Ref: Planning Objection - 21/03522/OUT
Date: 22nd November 2021

We are writing to make a strong formal objection to the planning application 21/03522/OUT - Land West of Yarnton based primarily on the failure to address increased risk of flooding to the existing community.

Figure 1 Map included in planning application

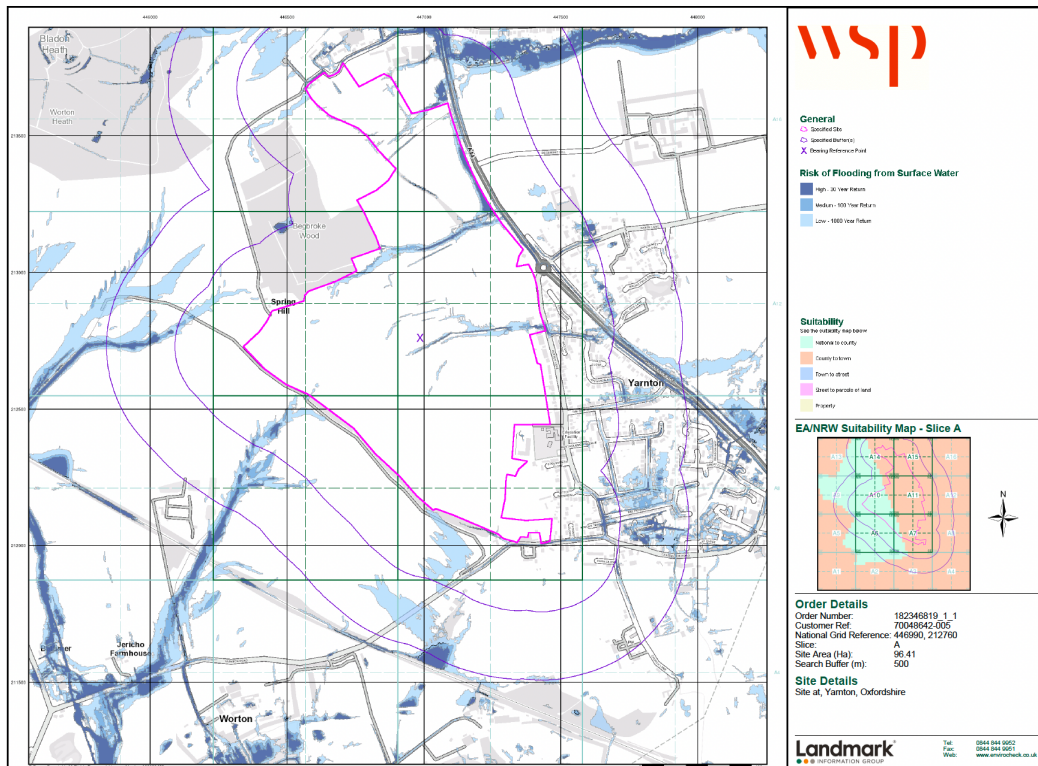
1. There is no acknowledgement or consideration of the combined flood risk at the development site and the existing village – there is a large omission in the flood assessment maps of the known River Thames Flood plain (see comparison maps figure 1 and figure 2 below).
